Subject: **PALO VERDE SOLAR 1, LLC'S INITIAL COMMENTS ON THE STAFF
ASSESSMENT/DRAFT ENVIRONMENTAL IMPACT STATEMENT
DOCKET NO. (09-AFC-6)**

Application for Certification for the
BLYTHE SOLAR POWER PROJECT

DOCKET NO. 09-AFC-6

**PALO VERDE SOLAR 1, LLC'S INITIAL
COMMENTS ON THE STAFF
ASSESSMENT/DRAFT
ENVIRONMENTAL IMPACT
STATEMENT**

Figure PD-1

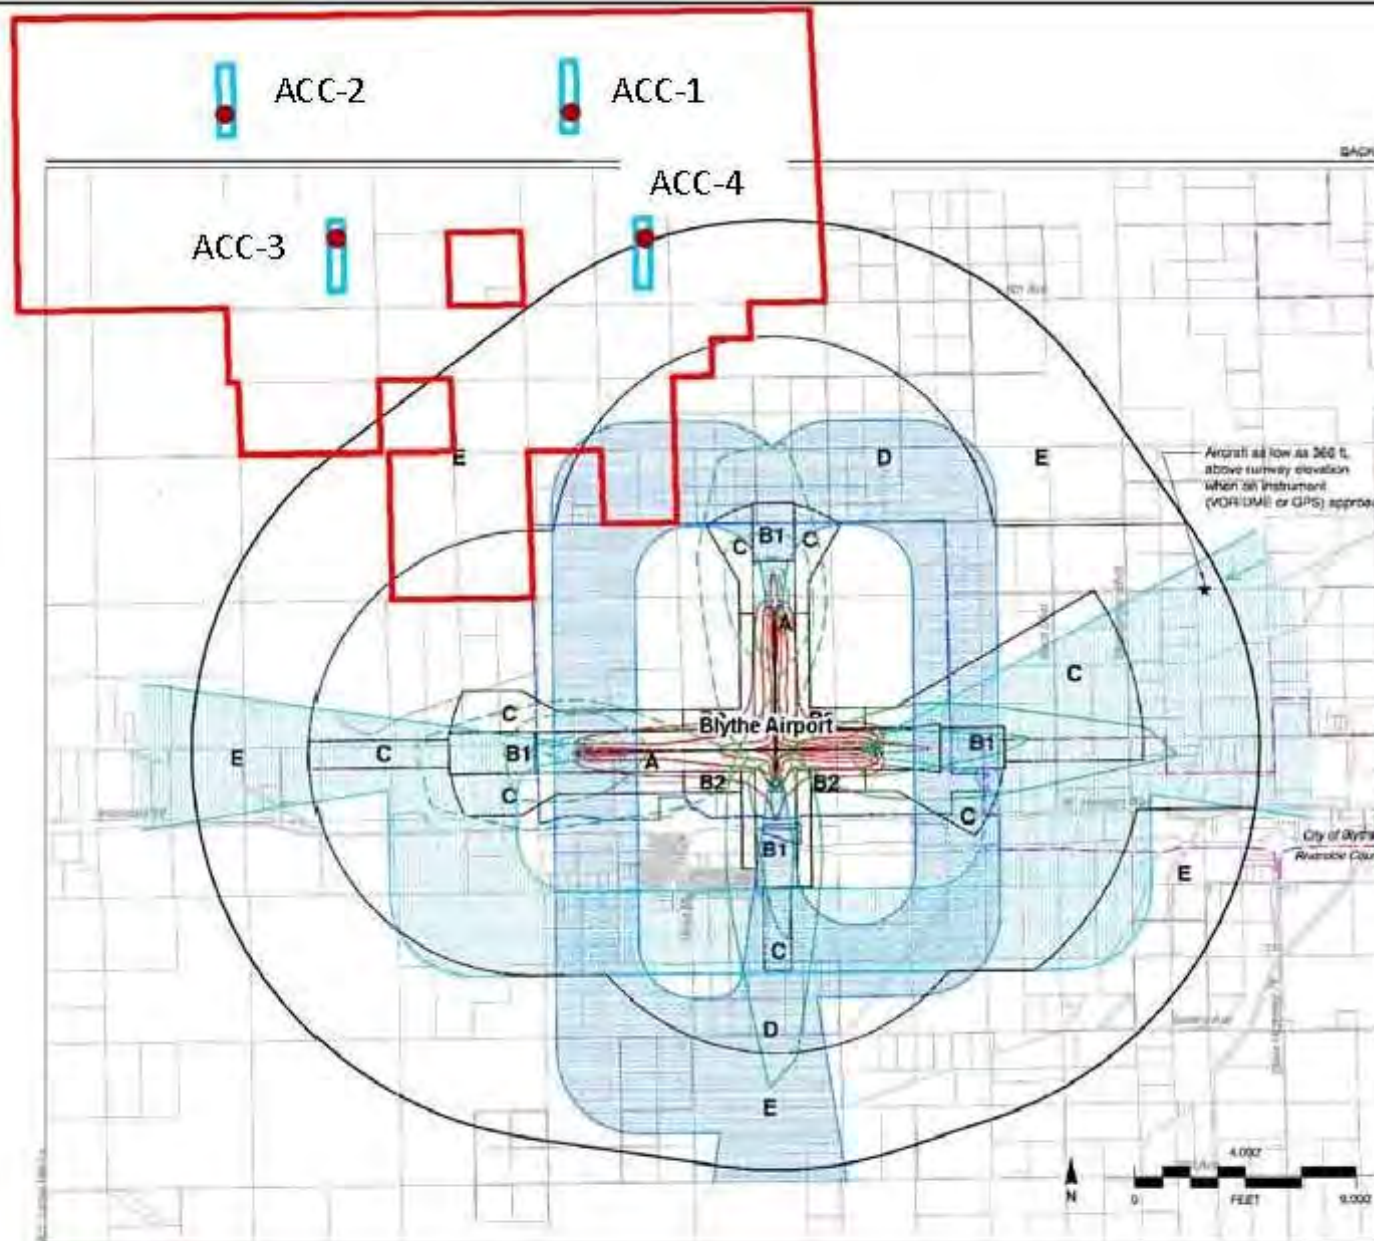
This section of the SA/DEIS indicates that the transmission line route is not yet finalized. The route for the gen-tie line between the BSPP site and the SCE Colorado River Substation has been selected and is shown in Figure PD-1. The required biological resources and cultural resources surveys for this route are underway and results will be reported when they are available later this spring.

Soil and Water
Figure 1
Groundwater Level
Contour Map

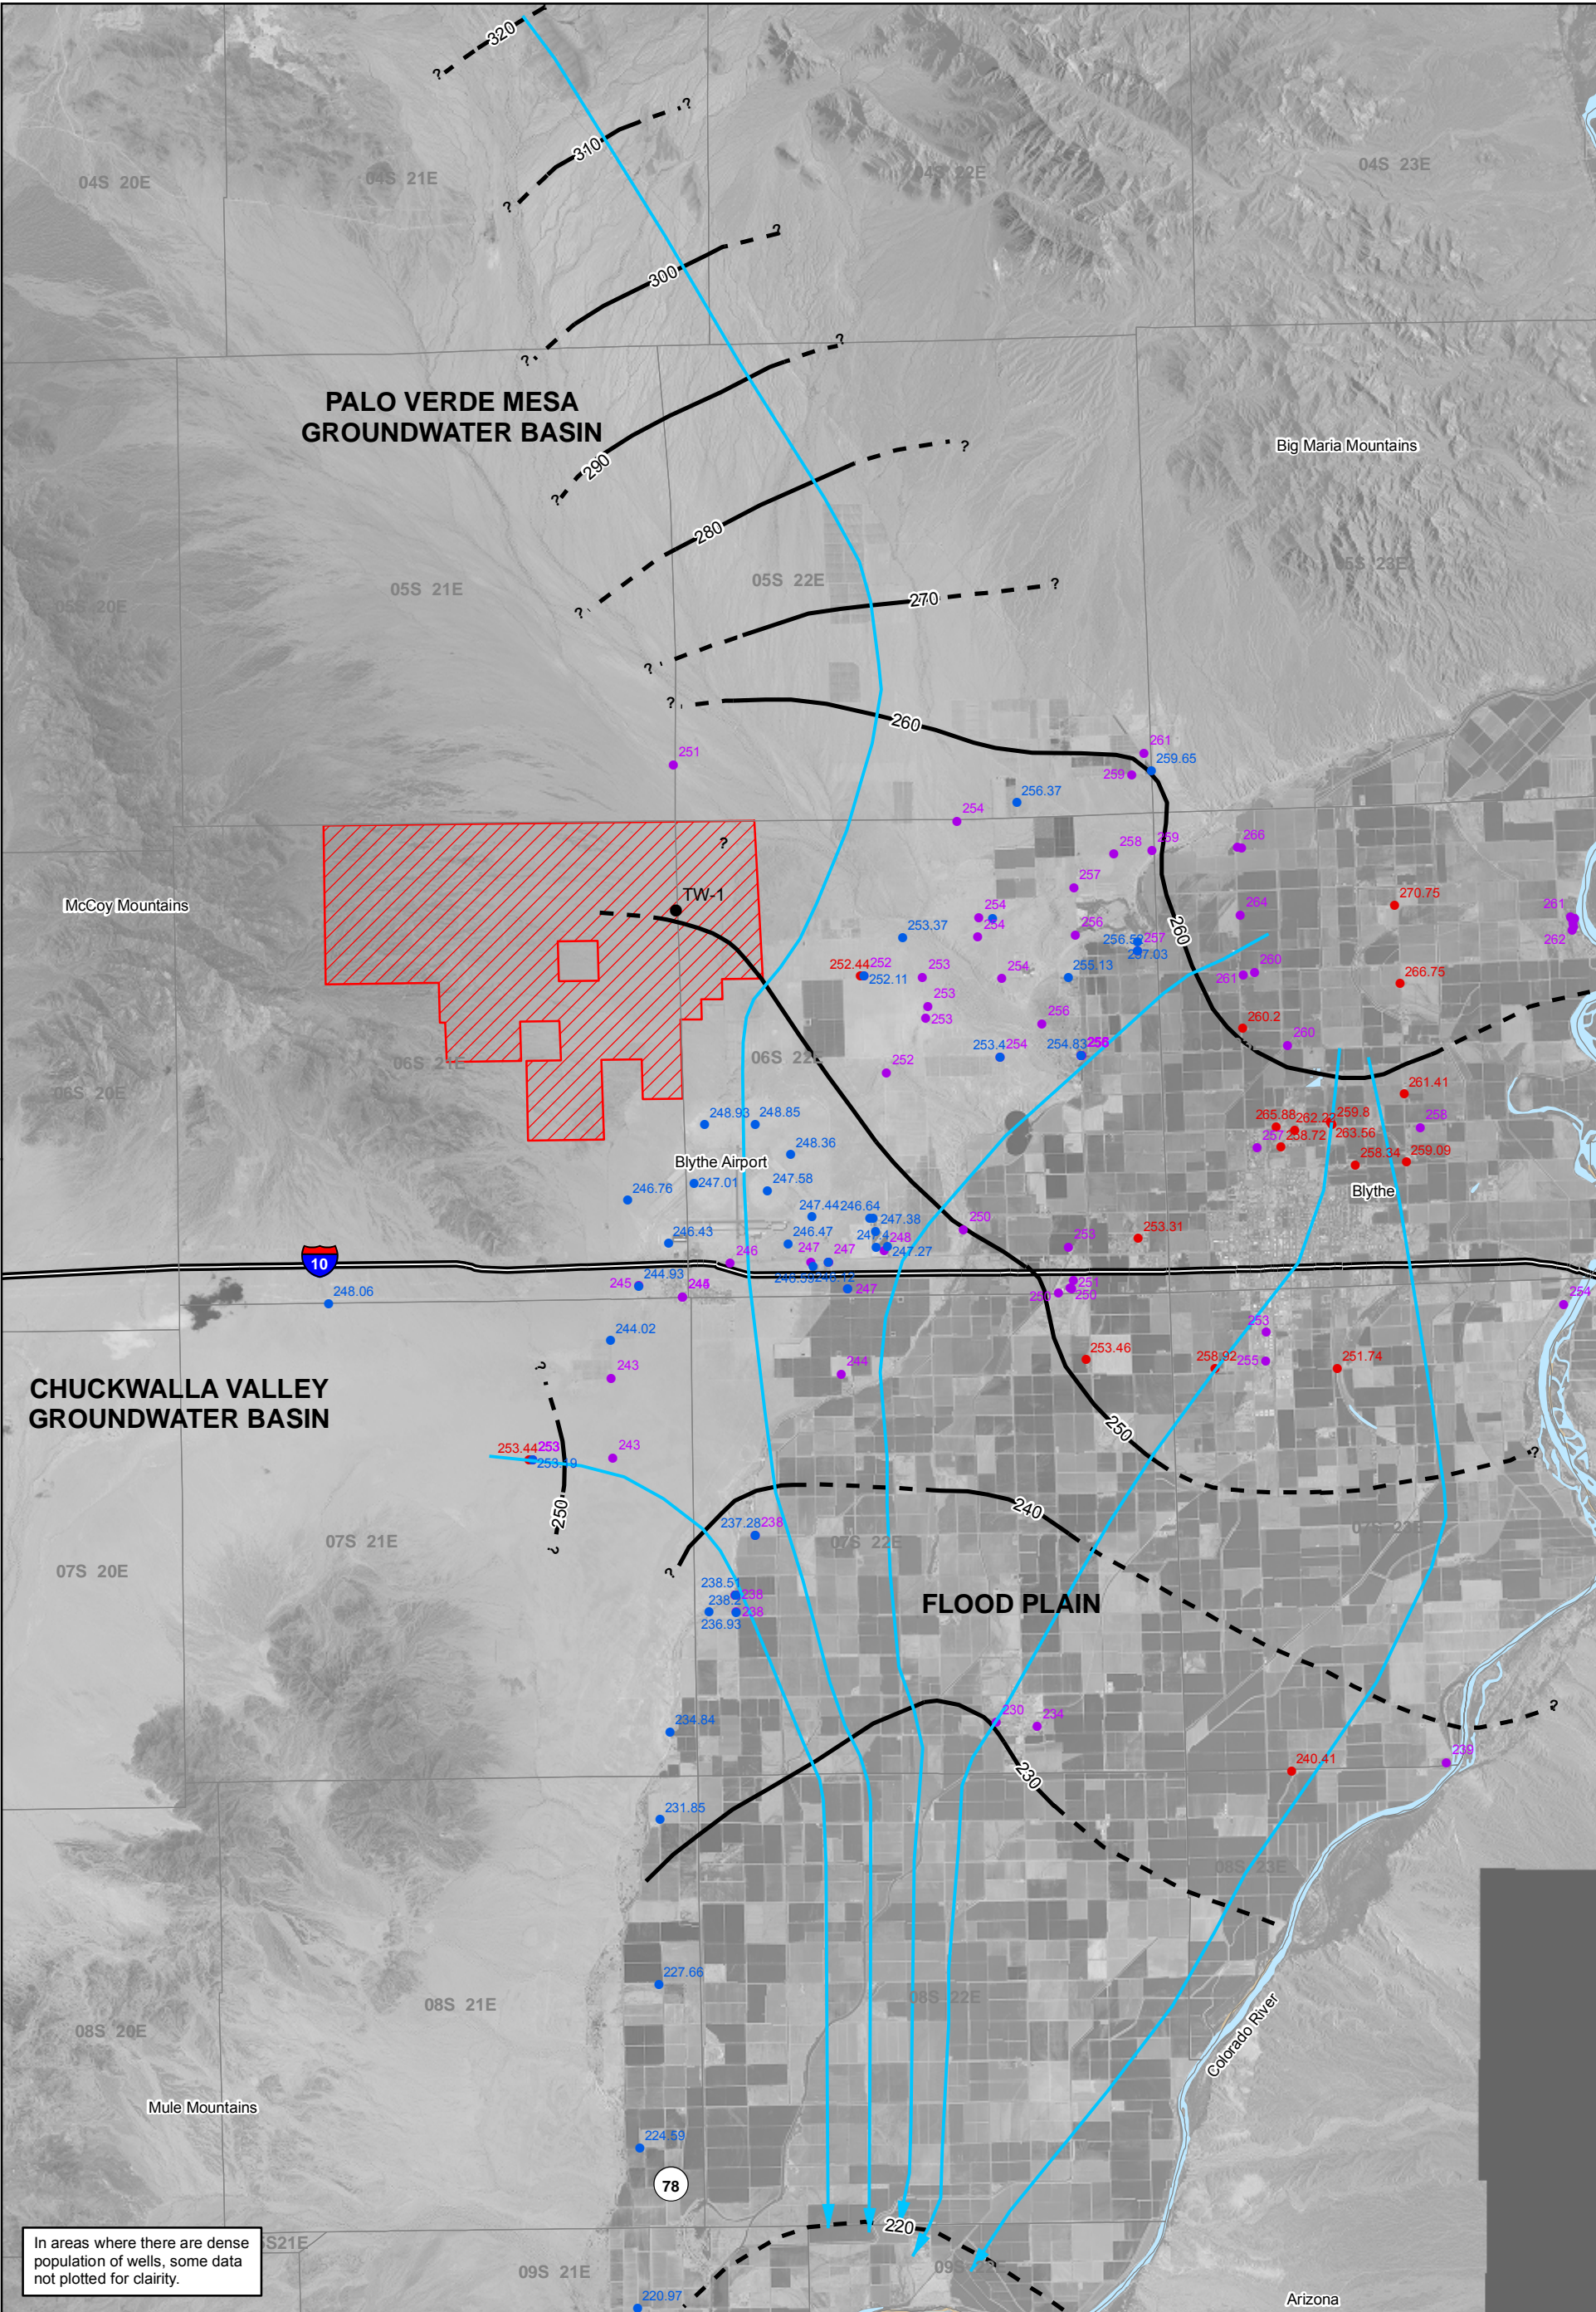
Soil and Water- Figure -1 shows the groundwater elevation for wells from available data gathered from 2000 to 2006. The water level contours and groundwater flow lines show that water below the Project site is from up-gradient sources within the McCoy Watershed and that there is a groundwater divide coincident with the flood plain and mesa where water from the river mixes with water from the McCoy Watershed. The water level map also shows that water from Chuckwalla Valley Groundwater Basin flows eastward into the Palo Verde Mesa and mixes with water from the Mesa eventually mixing with groundwater from the Colorado River in the central and southern portion of the flood plain. The groundwater flow lines indicate that groundwater pumping for the Project would preferentially draw water from up-gradient areas which would be from the McCoy Watershed.

Soil and Water
Figure 10
Northern Transect
Fluoride in Groundwater -
Mesa vs. Floodplain

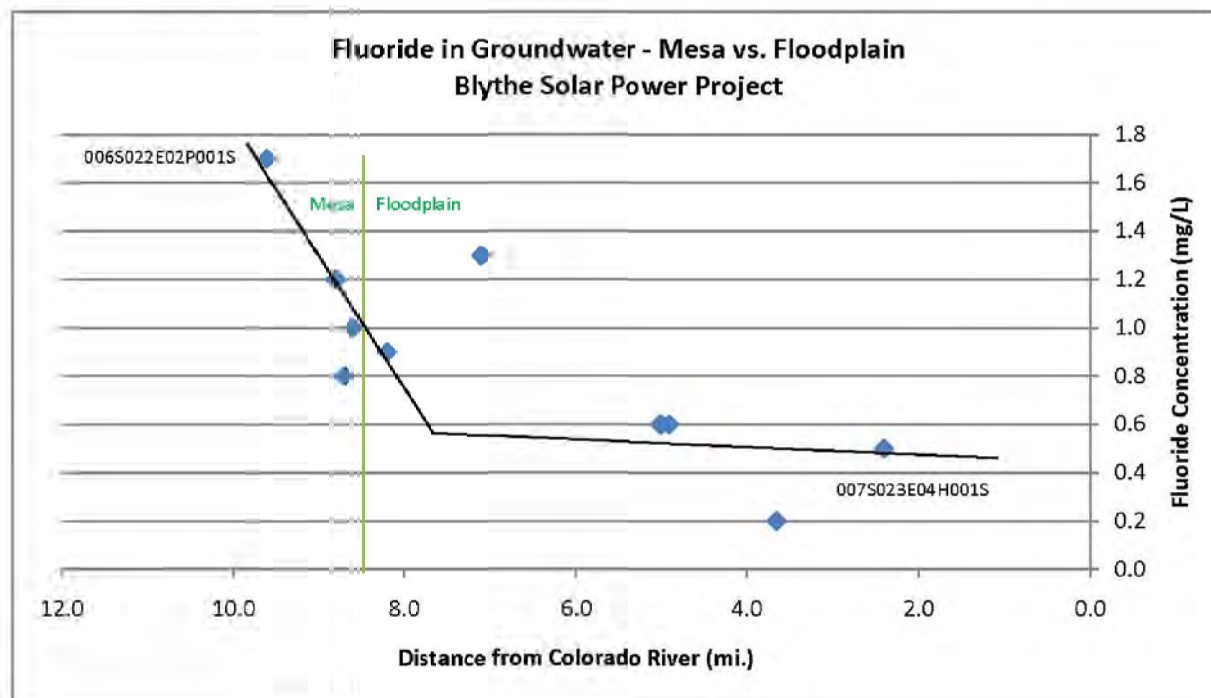
Soil and Water - Figures -7 through 13, are transects for two locations from the river and area north of the Project site and through the Project site. The graphs illustrate TDS, chloride, boron and fluoride concentrations with increasing distance away from the Colorado River. They provide additional data showing the changes in water chemistry, and thus water sources for the flood plain and the mesa.

Soil and Water
Figure 2
Water Type

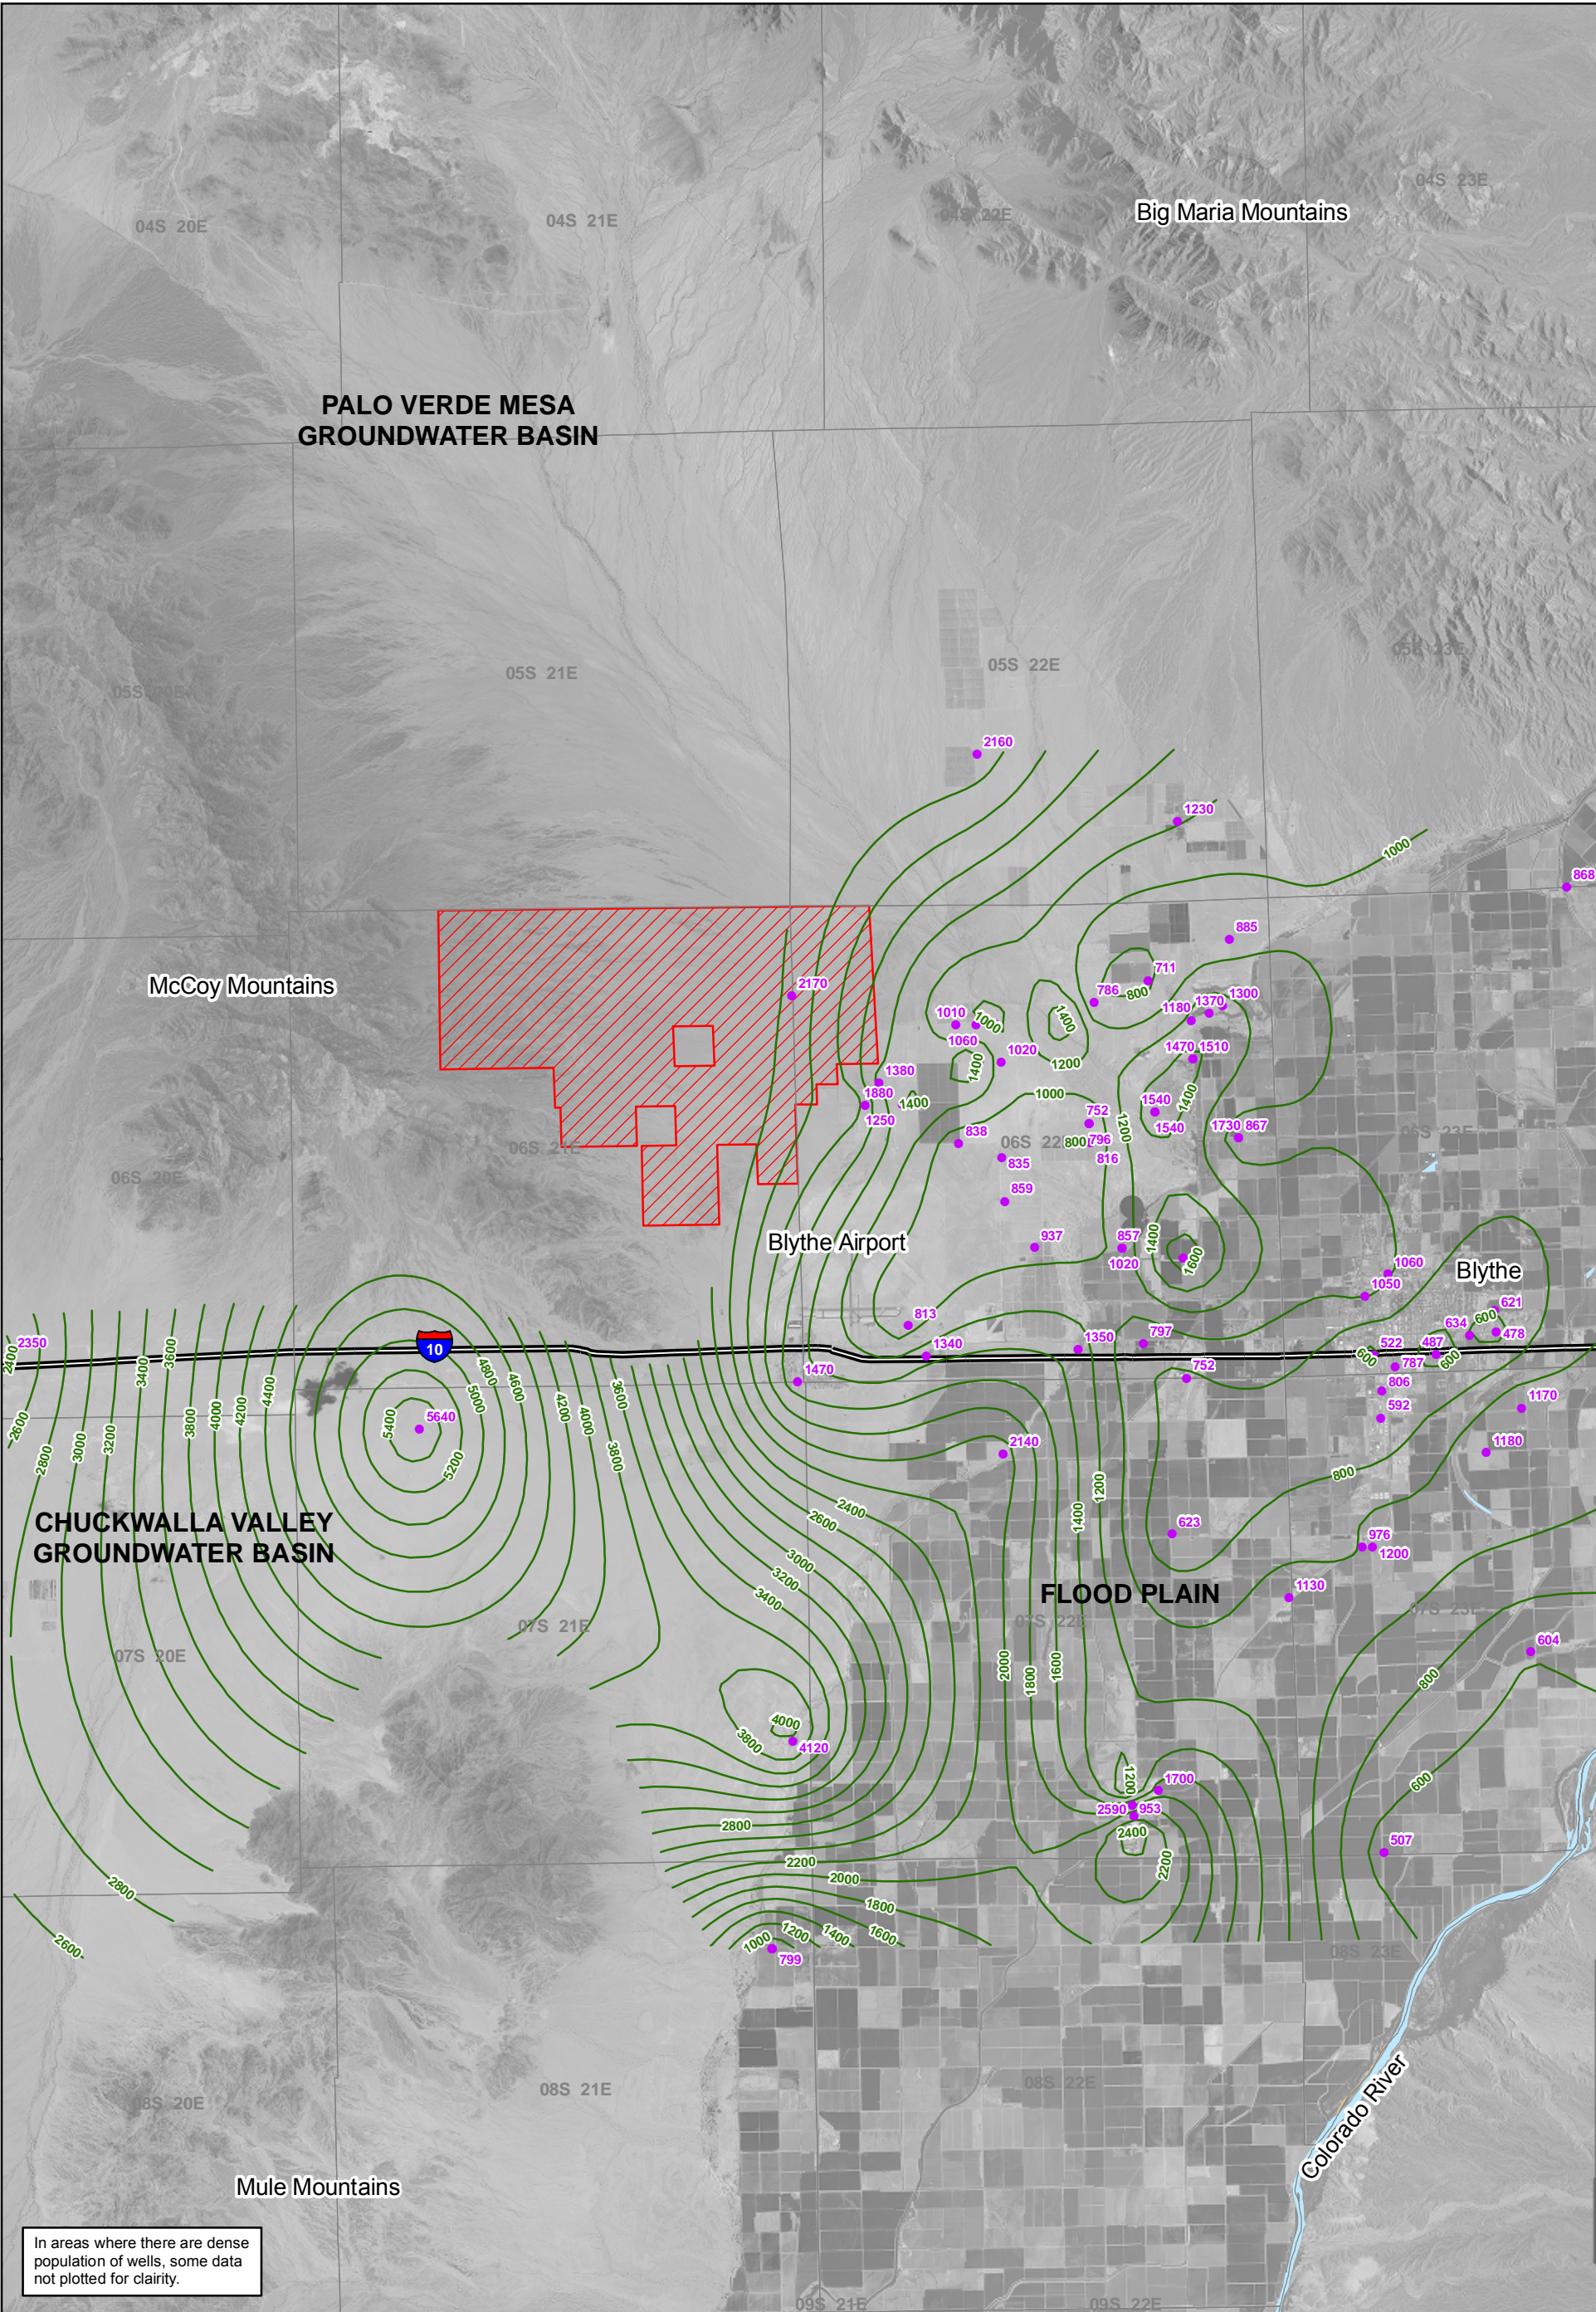
The available geochemical data also support the conceptual model that water below the site is from a source in the McCoy Watershed. **Soil and Water - Figure-2** is a Piper Diagram (Tri-linear plot) of the water types comparing water chemistry from wells near the River and those on the Mesa near the Project site. The data show that there are separate water types with water below the Project site as there is a definite contrast in chloride, and lesser so in sodium and potassium. The concept of different water types is further supported as shown on **Soil and Water - Figures -3 through 6**, which present the available data on total dissolved solids (TDS), chloride, boron and fluoride concentrations for wells in the flood plain and on the mesa. Iso-concentration maps were created using the program SURFER (ver. 8) to provide an assessment of the distribution of TDS and these anion concentrations across the flood plan and mesa. The distribution of TDS and anion concentrations further confirm the presence of a groundwater divide and mixing zone east of the Project site along the flood plain and mesa boundary. Both the TDS, chloride and boron data show clear changes in water chemistry from the flood plain across the mesa, and show a distinctive contrast in water chemistry below the site from that below the flood plain to the east.
